General Comments:

This manuscript presents a 40-year high-resolution gridded meteorological dataset for the Reynolds Creek Experimental Watershed in southwest Idaho, USA. This watershed is designated as a Critical Zone Observatory and is located in the rain-snow transition zone and snow-dominated semi-arid environments, which have experienced shifting due to climatic change. The manuscript describes how the high-resolution gridded dataset was developed from weather stations in this watershed. The presented dataset is extremely important to climate change, hydrology, and ecology related research and can make contribution to understanding climatic change response in the rain-snow transition zone. In addition, the dataset is valuable forcing data for hydrologic model benchmarking and development as well as validation data for atmospheric reanalysis model outputs. The dataset stored in the data repository mentioned in the manuscript meets the standard of usefulness and completeness and can be readily accessed and extracted in the methods described in the manuscript. Overall, the manuscript is well written and easy to follow and should be acceptable for publication with minor revisions

Reynolds Creek Experimental Watershed

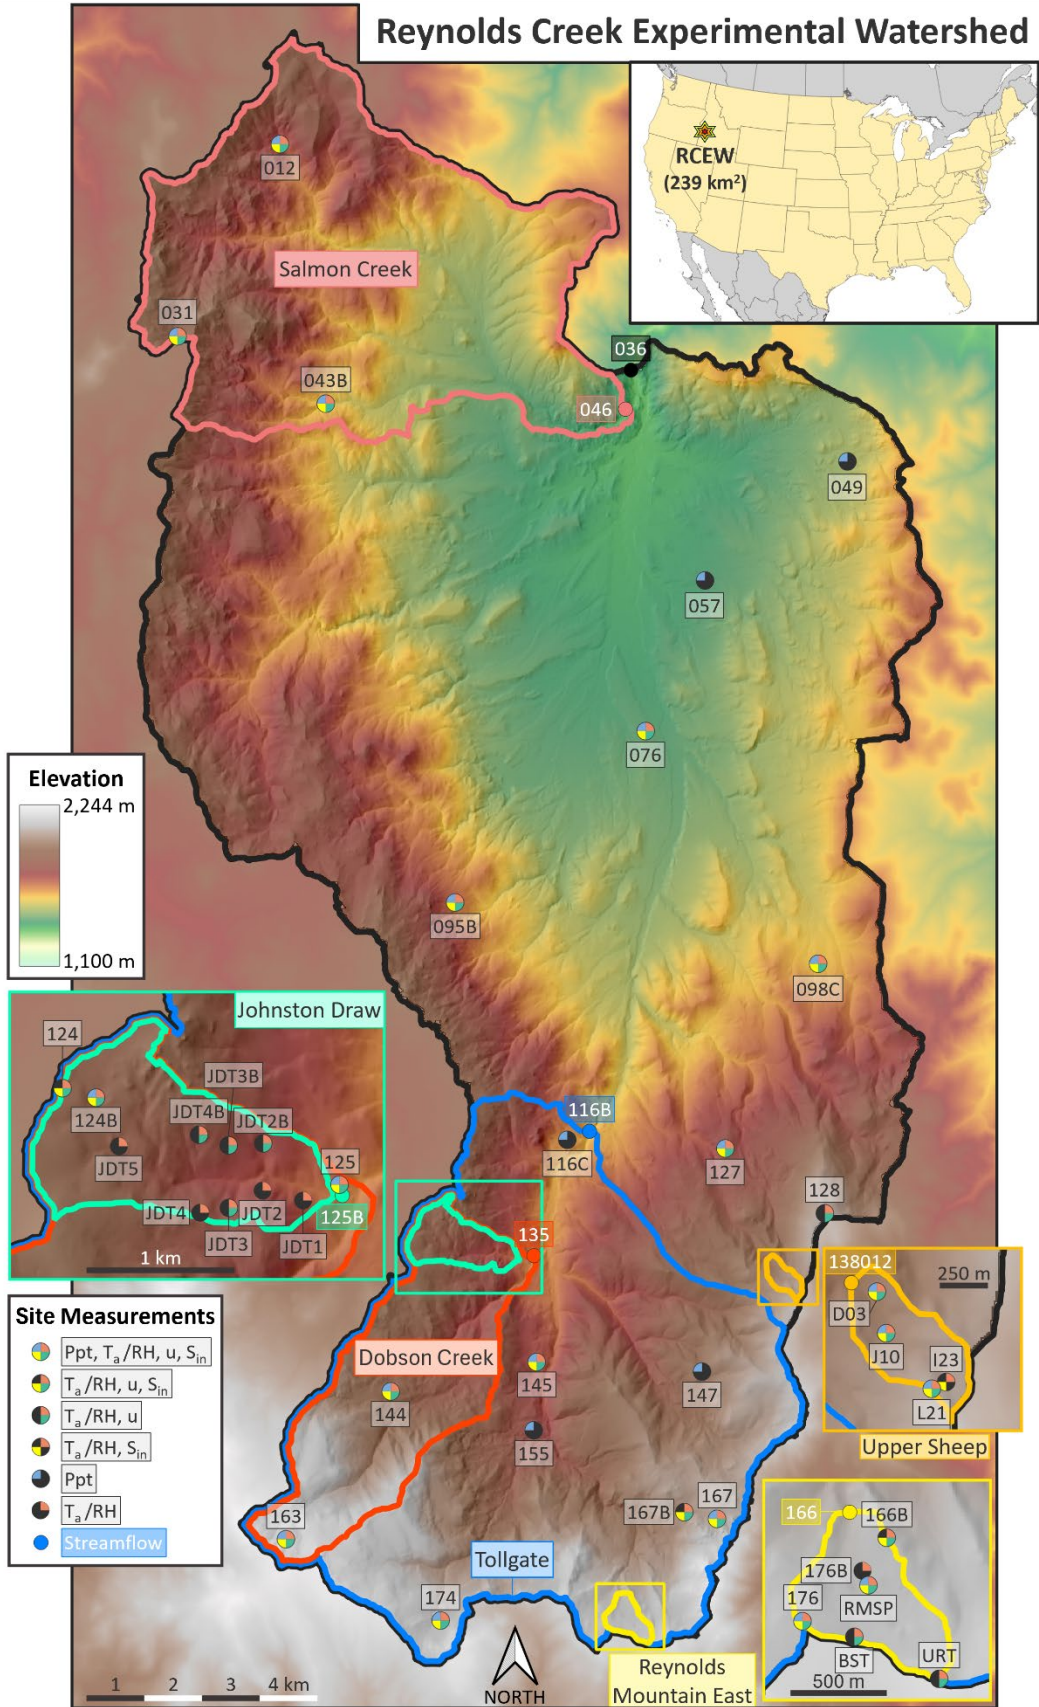
1. In Figure 1, the red box weir number, i.e., 135 appears in the inset map of Johnston Draw sub-watershed, while the weir number 135 is for Dobson Creek sub-watershed. I suggest authors move the red box 135 out of that inset map and place it in the main map. **DONE**. In addition, use a thicker red color outline for the boundary of Dobson Creek sub-watershed, as it is barely visible with the thin outline. **DONE**. This is same for pink color outline for Salmon Creek sub-watershed, use a thicker outline to improve readability. **DONE**. Also, I suggest authors perhaps include an inset map showing the location of RCEW in USA for general readers who are not familiar with the watershed. **DONE**. We include here the revised Figure 1.
